BGA TECHNICAL COMMITTEE

TNS 7/8/85

PART 1 Airworthiness "Aggro" (Please add to the 1985 Green Pages)

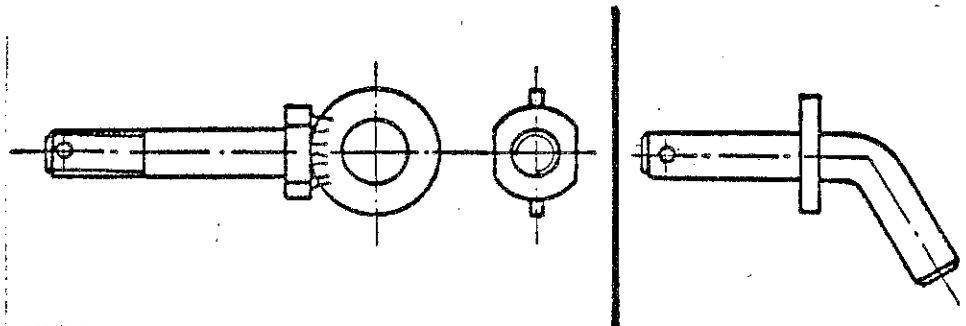
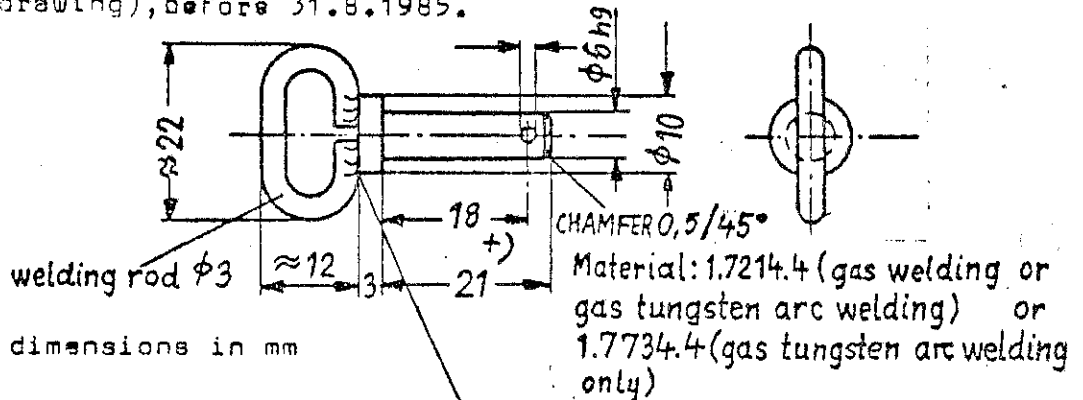
Reason: On some "Bergfalke" Sailplanes (not all), a connection bolt for elevator and airbrakes was installed, made of an eyebolt with a welded handle (made of welding rod) (see sketch)

Under bad circumstances the molecular of the eyebolt (DIN material), can change during the welding of the little handle to the bolt.

There has been a damage to a bolt for the airbrakes. For the safety, it is necessary to inspect the DIN-bolts for eventual cracks and before 31.8.1985 replace them against bolts made of "Aircraftsteel" (1.7214.4 or 1.7734.4 (see drawing Instruction 3)).

Before next flight the connection bolts must be inspected by using a magnifying glass of at least 10 x power. If cracks are found, then the bolt must be replaced immediately. If no cracks are found the sailplane may be flown until 31.8.85.

If the connection bolts are not made of "Aircraftsteel", they must be replaced against such of aircraftsteel ( see drawing), before 31.8.1985.

+) a certain amount of Bergfalke's are "amateur-build".<sup>chamfer</sup> Therefore there may be differences in the length of the bolts, and they must be fitted to the actual Bergfalke. In any case with the new connection bolts the controls must be checked carefully on function and clearance.

T53 WING CENTRE SECTION JOINTS  
TO FRAME 6

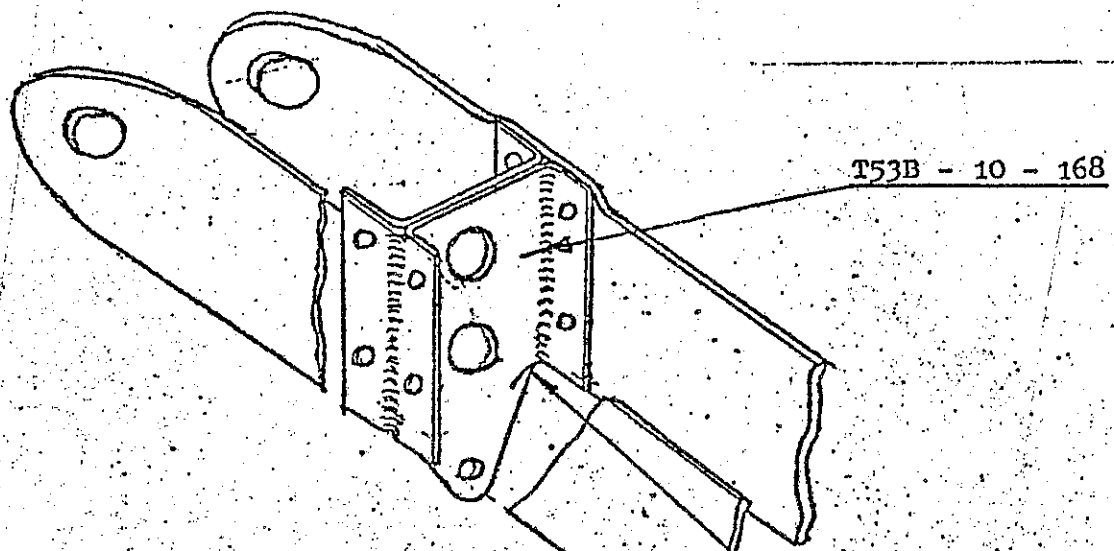
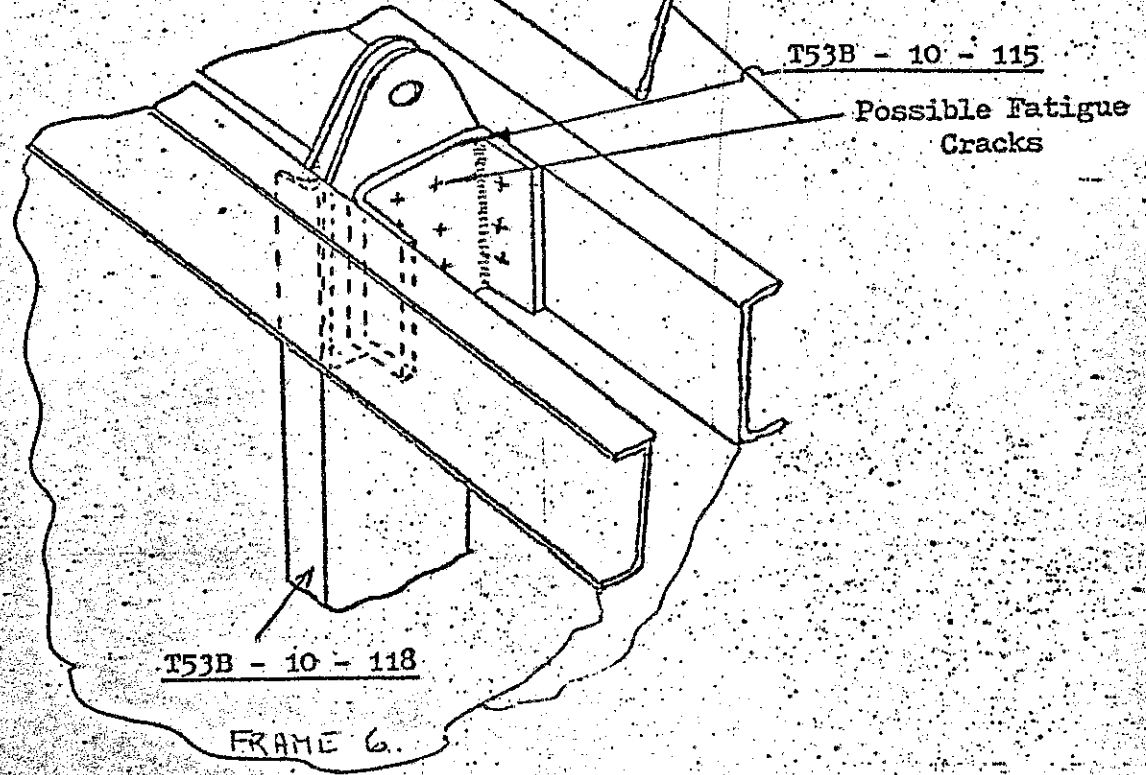
TITLE	T.I.No. 100/T53 Issue 1
Inspection of attachment of wing centre section to Frame 6.	
COMPLIANCE	
CAA MANDATORY Inspection to be completed before next flight and annually thereafter.	
JUSTIFICATION	
This is a re-issue of the information of TI 90 which this instruction hereby cancels and replaces. A failure in fatigue of the brackets which holds the rear spar member of the centre section to Fuselage Frame 6 has been reported.	
APPLICABILITY	
All T53B gliders and to later variants of YS 53 by Yorkshire Sailplanes.	
RESTRICTIONS	
The glider must not be flown until this Technical Instruction is carried out.	
OBJECTIVE	
To inspect for fatigue cracks in the affected parts listed below :	
T53B-10-168 issue 1-4 welded fittings	
T53B-10-168 issue 5 rivetted "	
T53B-10-118 issue 1	
T53B-10-115	
PARTS REQUIRED	
In the event of cracks in any of the fittings then they must be discarded and new parts fitted.	
PROCEDURE

Remove glass fibre fairing No.T53B-10-1093 and wings if fitted. Using a Dye penetrant crack detection system, inspect for cracks at the corner of the fittings where the attachment flanges begin (a) the welded brackets Pt No.T53B-10-168 issue 1-4 see figure 1 page 2 which holds the rear spar member of the c/s to the fuselage frame 6 and (b) the alternative riveted bracket Pt No.T53B-10-168 issue 5. Also in a similar manner inspect the metal lugs T53B-10-115 and channel section T53-10-118 on frame 6. See Figure 2. Checking for cracks in way of rivets.	
If any cracks are found the aircraft is to be grounded. All findings to be reported to SEL marked for the attention of the undersigned. New components can be obtained from SEL if required as listed above. If there are no cracks the aircraft is cleared for flight.	
Once the inspection has been complete the TI 100/T53 action should be recorded in the aircraft log book.

ASW 19/20 ELEVATOR 1.8:  
BGA TNS 7/8/RS

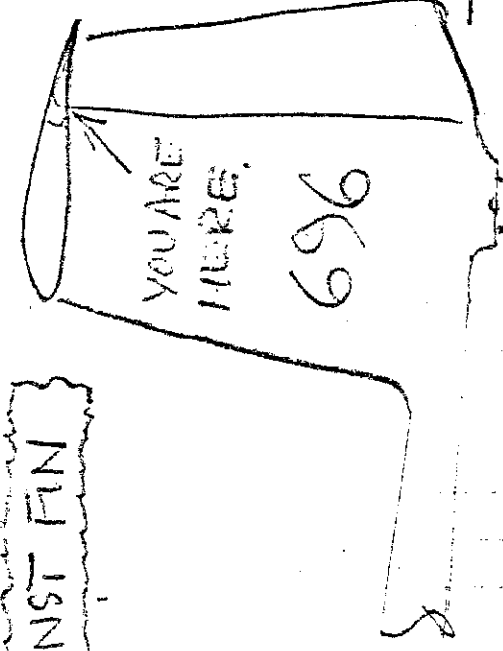
- 1.8 ASW 19/20 ELEVATOR LOCK PIN. The attached sketch by Chris Batty introduces additional safety device. ASW Tech Note 17 also illustrates this modification, which will only be effective if you remember to couple-up in the first place!

PIN MUST BE SHORT ENOUGH TO AVOID FOUL AGAINST FIN

PIN ACTUAL SIZE  
BENT FROM ZOSWOG, PIANO WIRE  
FROM LOCAL MODEL SHOP,  
KNOTTED & GLUED  
DRILL DIAGONAL HOLE IN ELEVATOR

A5020 (219) RUDDER BAR CABLE END BEND

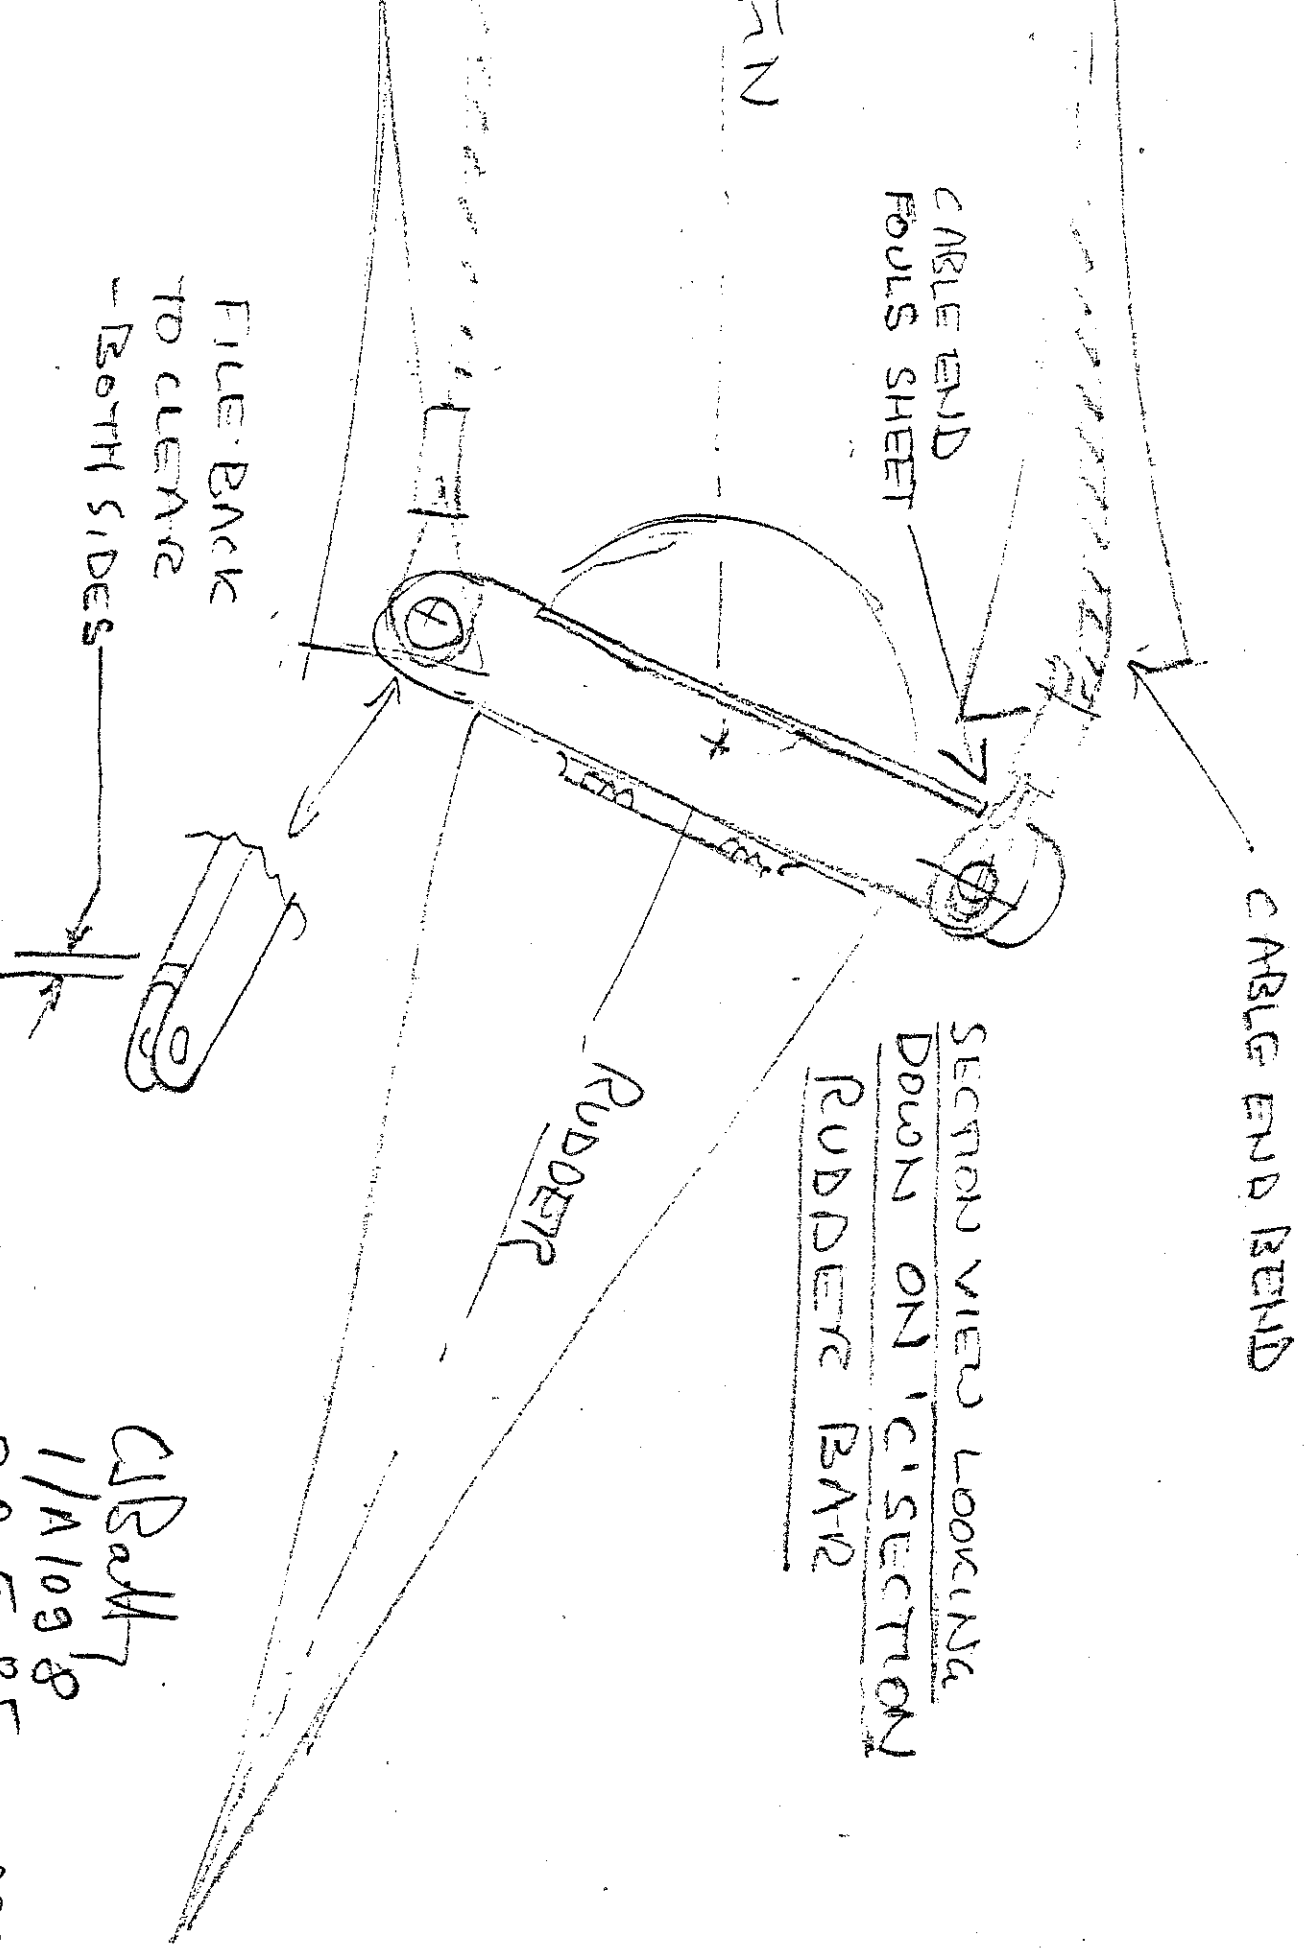
- 1.9 ASW 19/20 Rudder Cable END BEND at Rudder. Attached sketch by Chris batty illustrates potential fatigue failure.
- 1.10 LIBELLE (Standard) - Elevator Vibration. Backlash in the elevator drive must be minimal if "flutter" (which might cause damage) is to be prevented. (Reported by Kent GC)

FILE BACK  
TO CLEAR  
- BOTH SIDES

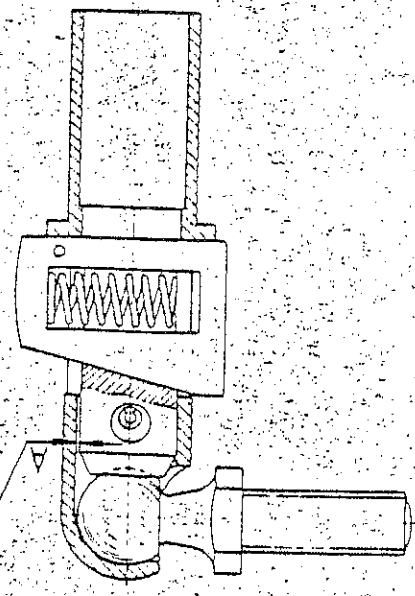
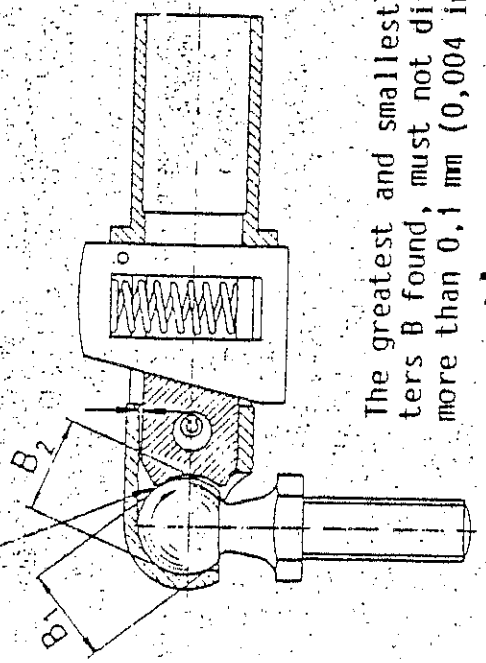
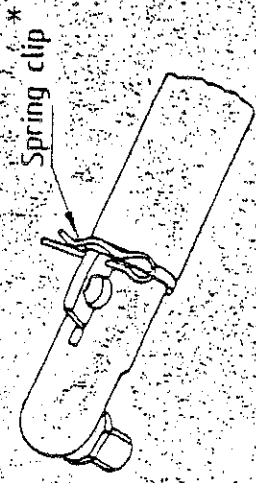
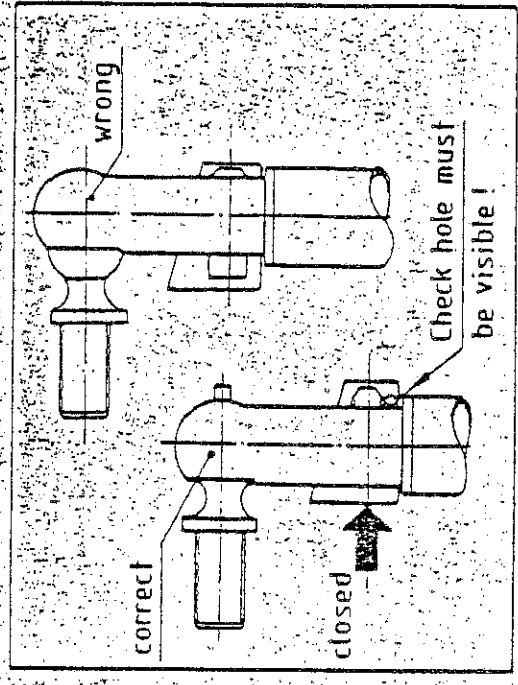
- 1.13 L!Hotellier Quick-Close Connectors. Periodic Inspection. The attached extracts from ASW 20L ( T Note 17) applies to the above connectors, regardless of application.

Bad wedging effect causing wear of the ball end.

Clearance A must not exceed 0,15 mm (0,006 in); check by using a wire of 0,15 mm diameter !

The greatest and smallest diameters B found, must not differ by more than 0,1 mm (0,004 in).

According to experience accumulated in Australia the following inspection of the L'Hotellier connections must be carried out at every annual inspection, especially when the glider is operated frequently from sandy and dusty airfields.

DE-LAMINATION INSPECTION.  
ELEVATOR DRIVE SUPPORT.

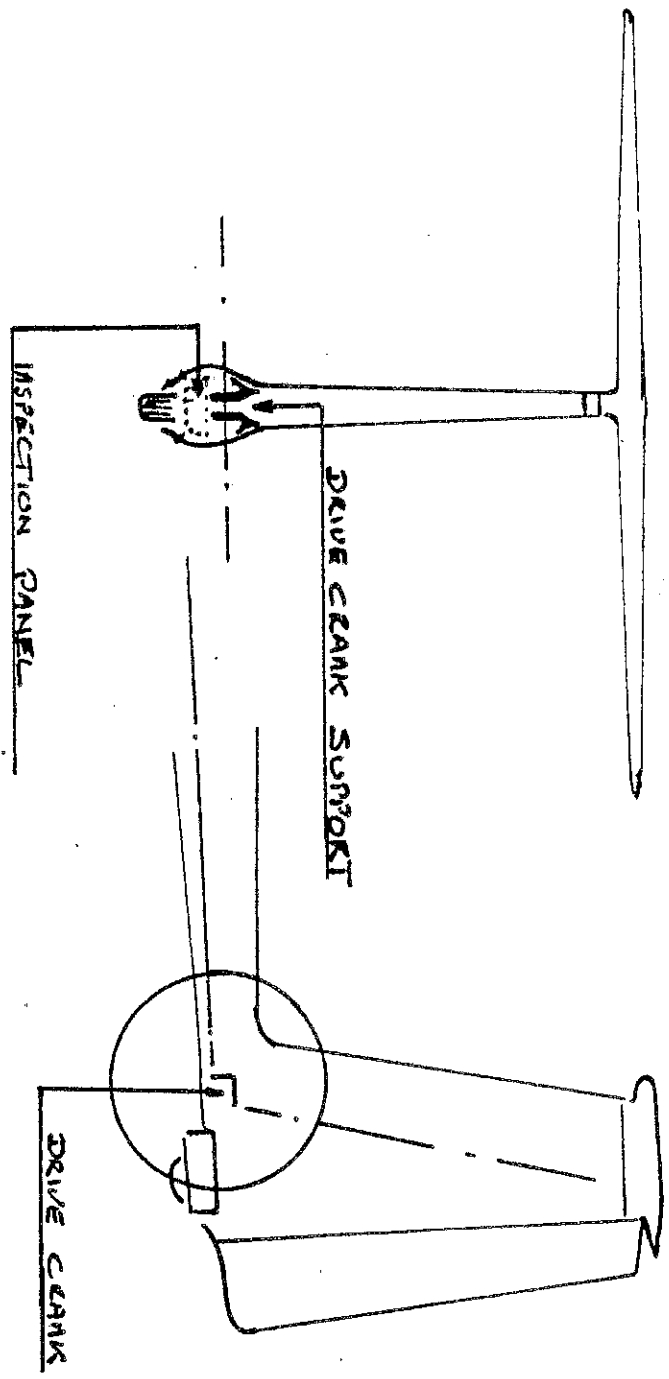
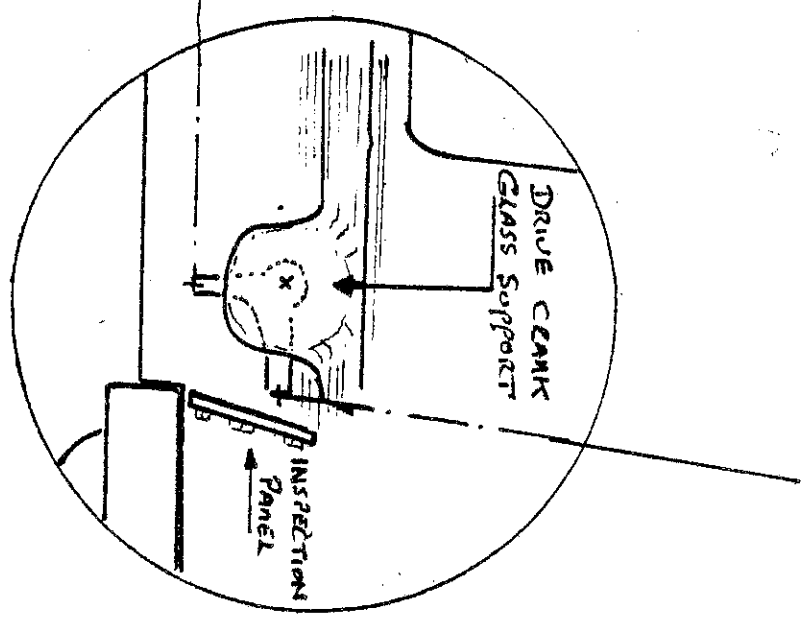
- 1.17. T.65 VEGA Delamination of elevator drive support at base of fin - (sketch attached - reported by J. Clarke, M.G.C.)

De-lamination & general malformed elevator drive crank support yoke  
Angle mirror must be used & inserted along side support, to inspect.

Fig. 20. Elevator control

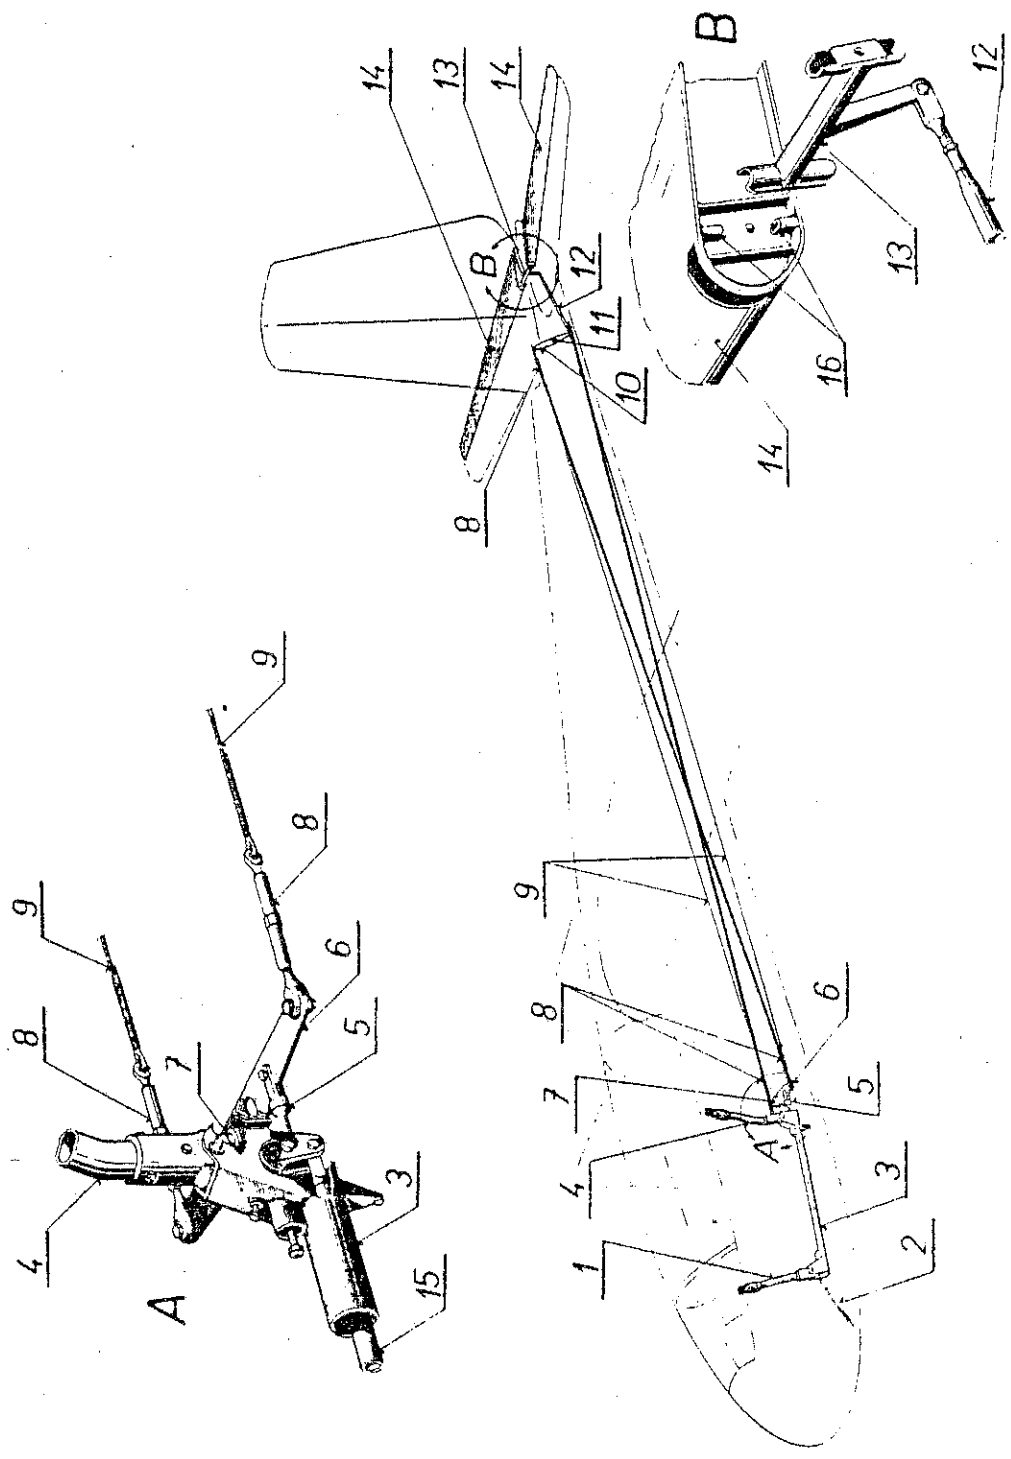
- 1.12 Blank Elevator Drive Cables. Page 38 of the Manual illustrates incorrect routing of the cables (in parallel), whereas to achieve the correct operating sense the cables must cross over (sketch attached). Reported by Jeremy Bryson, Ulster GC.
